THE CITY OF MARYSVILLE
MARYSVILLE, CA

ADDENDUM NO. 2

BINNEY JUNCTION SEWER MAIN RELOCATION PROJECT
CONTRACT NO. 26-01

UPRR shoring zone general requirements:

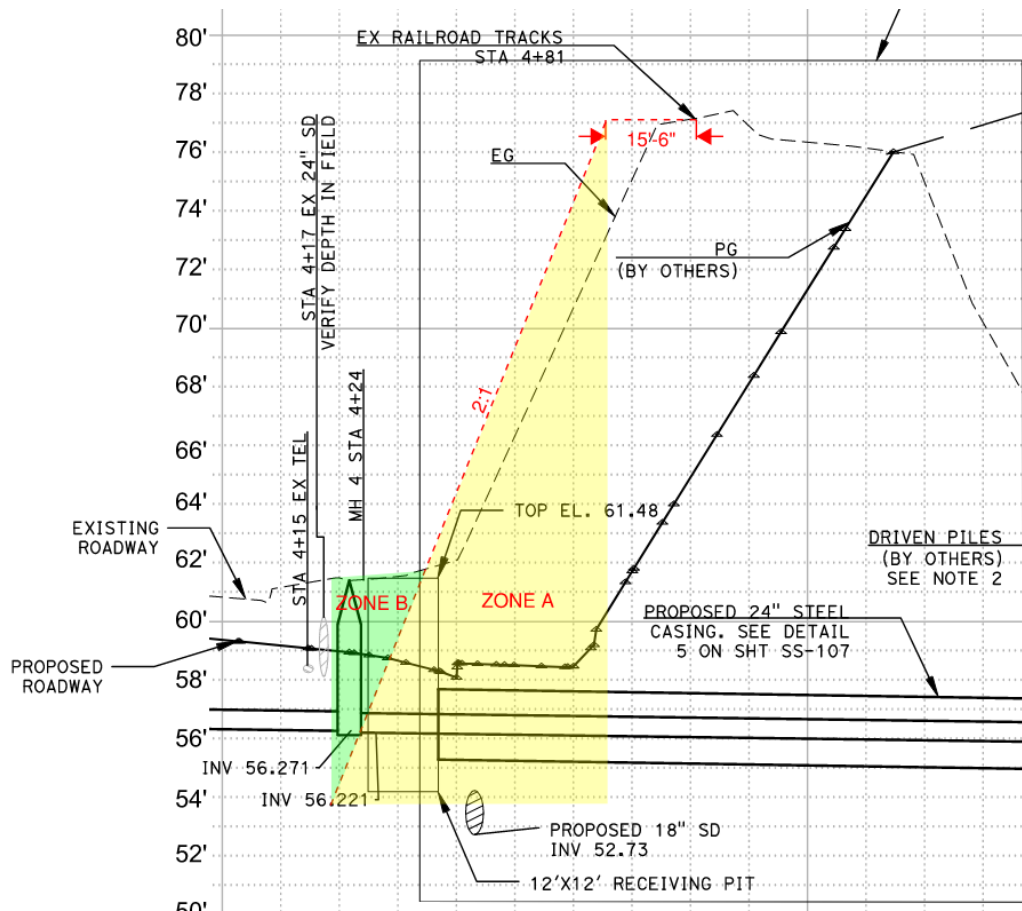
1. **Question:** On Sheet SS-102, the plan view identifies the horizontal limits of Zone A, while the profile appears to identify different vertical extents. Based on our review, the Zone A limits shown in profile extend significantly farther toward the receiving pit than the Zone A limits depicted in the plan view. Please confirm the intended limits of Zone A and identify which depiction governs for construction of the jack-and-bore crossing.?

2. **Question:** Based on the Zone A limits shown in profile view, the receiving pit may fall partially or entirely within Zone A. The UPRR permit and contract documents do not appear to provide specific requirements for excavation support or shoring within Zone A. If the receiving pit is located within Zone A: Are there any special shoring, excavation support, or engineered protection requirements beyond standard OSHA requirements? Does the requirement that work be continuously progressed through Zone A apply only to the bore operation beneath the tracks, or does it also apply to excavation and work activities within the receiving pit?

Response: The plan limits just depict the limits based on the required offset from the tracks, but the profile view indicates the limits based on the 2:1 zone of influence. The additional area would only impact the shoring requirement on a portion of the receiving put to meet the UPRR requirements. See below.

Response: As shown above, Zone A does include most of the receiving pit. Because of this, the shoring design for the receiving pit will need to account for railroad live load surcharge in addition to OSHA standard loads. The jacking pit just needs to account only for OSHA loads. The continuous work applies only to the boring and casing installation.
